ITEM FOR ENVIRONMENTAL COMMISSION AGENDA

NAME & NUMBER OF PROJECT: The Holdsworth Center SPC-2017-0513C

REQUEST: Variance request is as follows:
 1. Fill exceeding four feet in depth in DWPZ, not to exceed 10
 feet.

Development Services Department
Staff Recommendations Concerning Required Findings

EXHIBIT 1

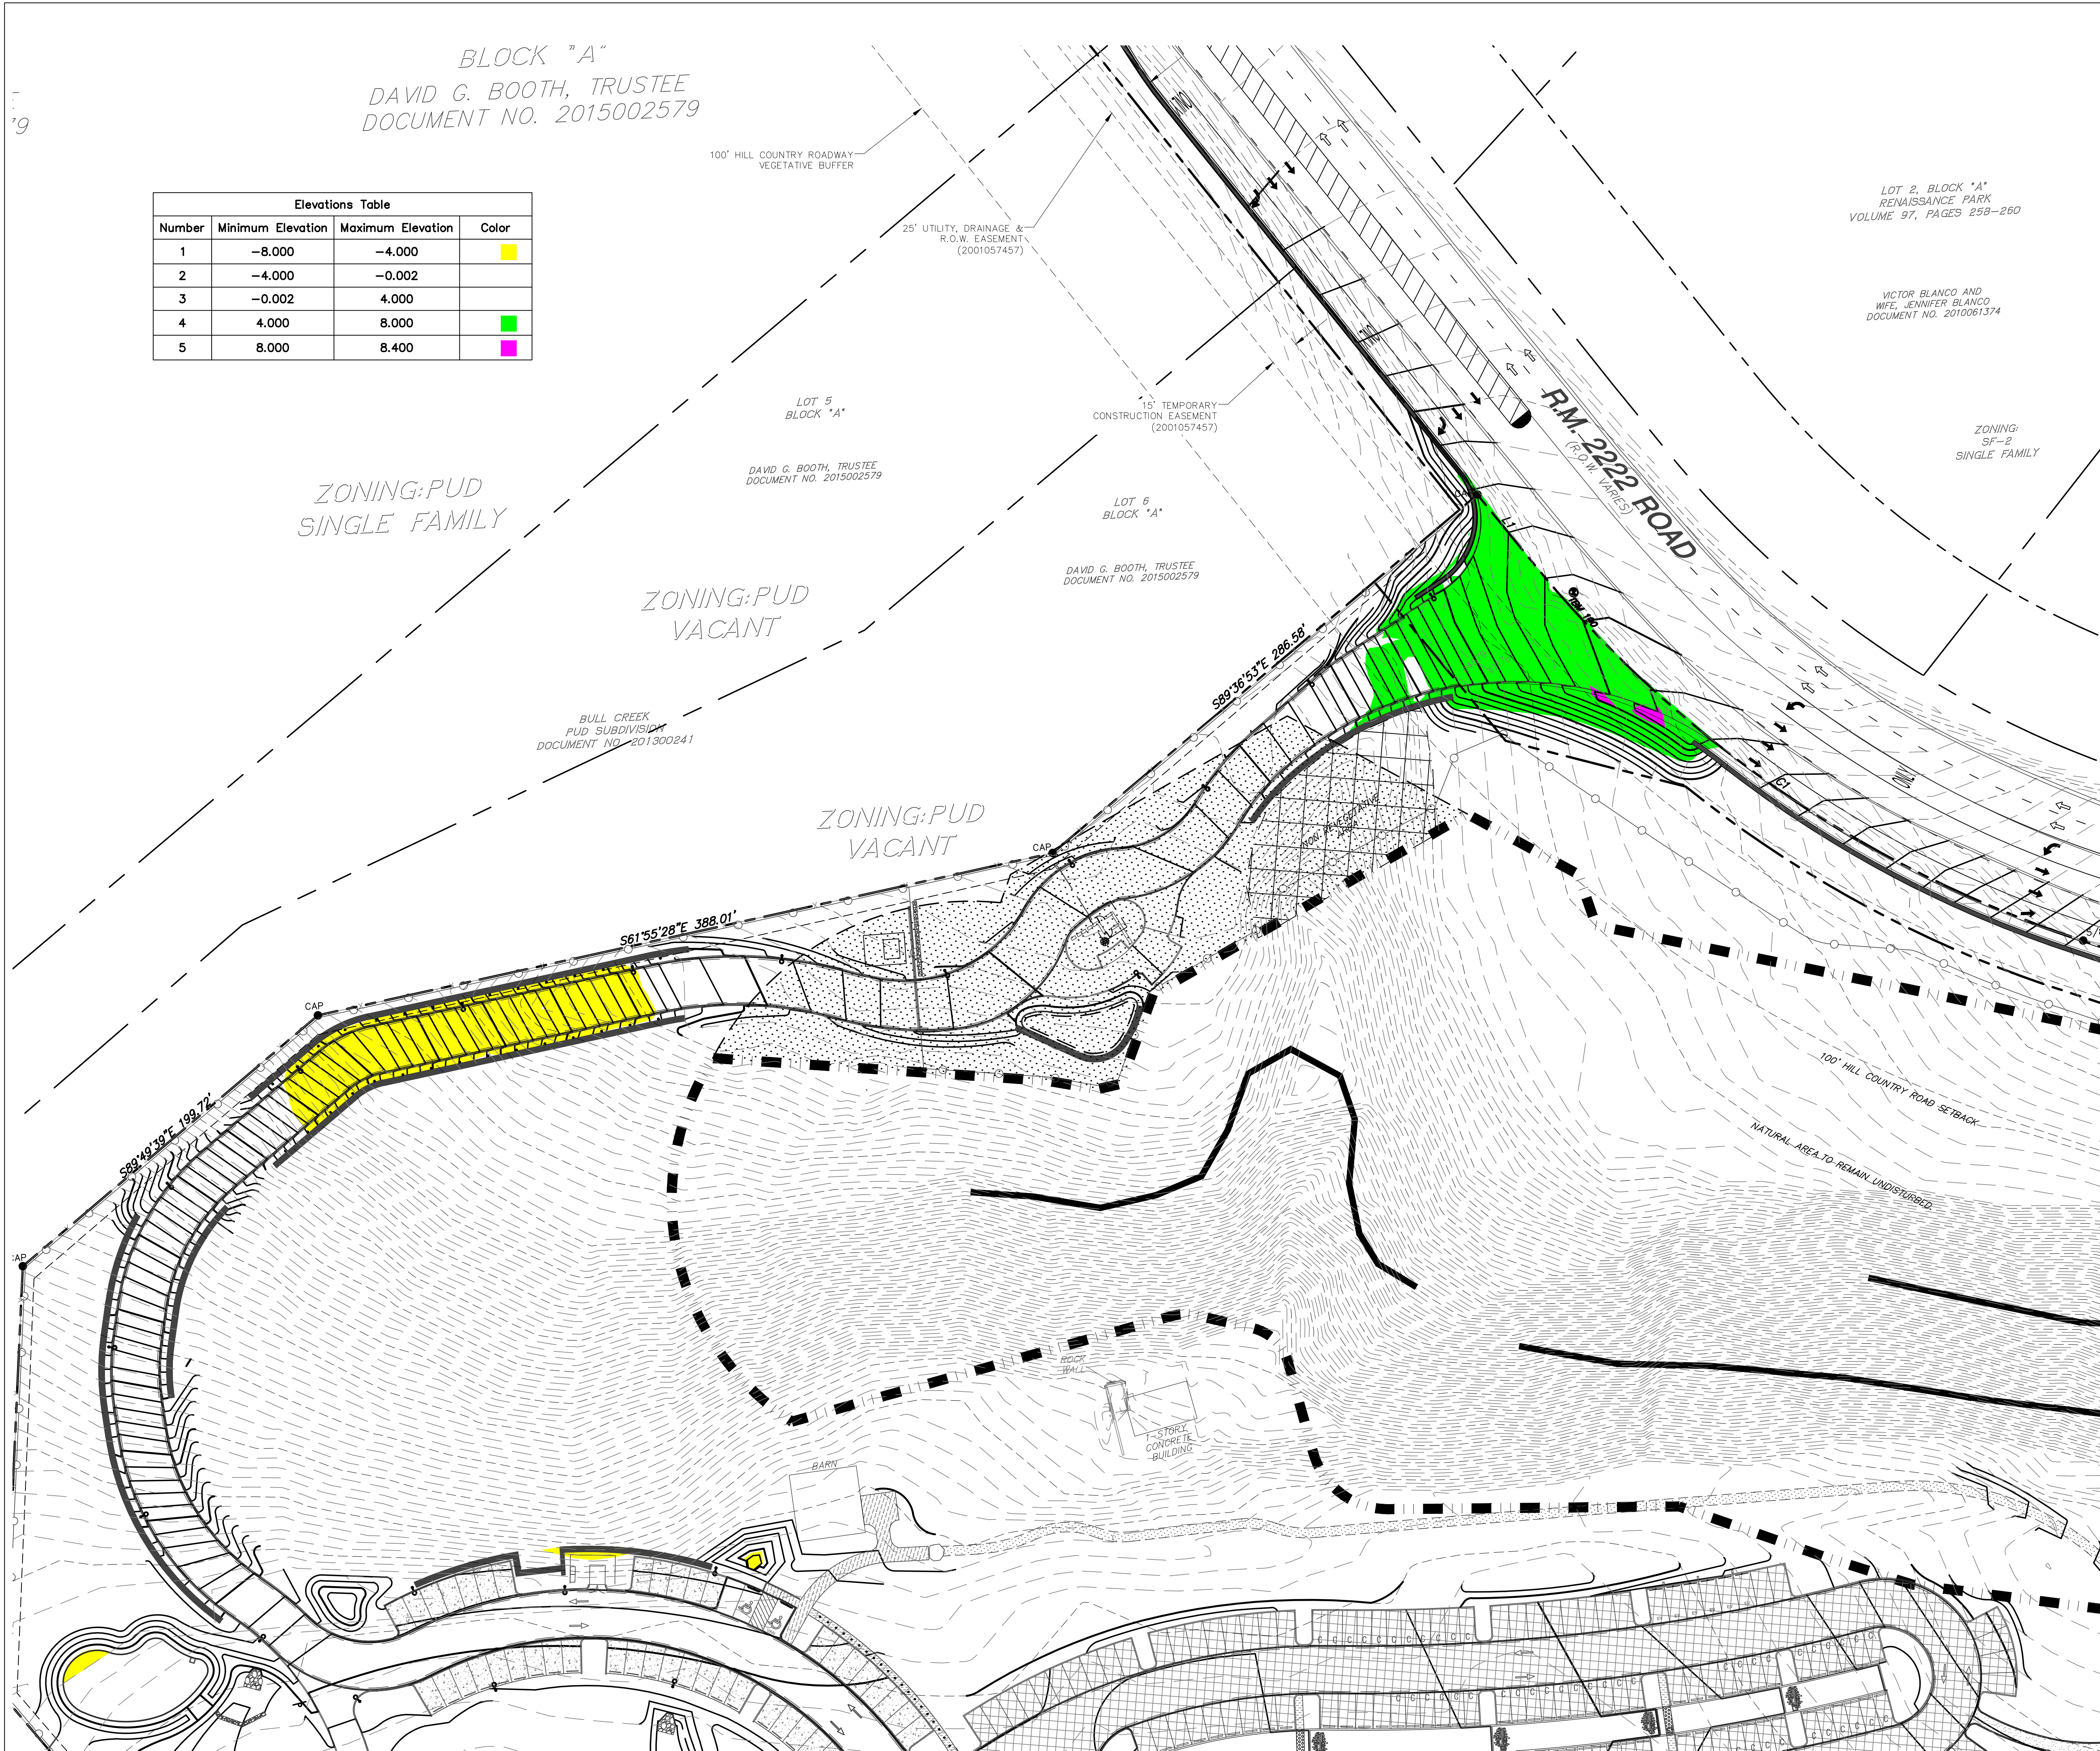
Yes. The entry drive is designed in such a way to reduce the amount of fill required to the least extent possible while still maintaining safe ingress/egress to the site (see Exhibit 1).

Staff recommends approval of the requested variance with the following conditions:

- The extra fill must be outside the ½ critical root zones of protected trees and be structurally contained using retaining walls.
- The structural containment must be constructed prior to construction of the fill associated with the need for the variance.
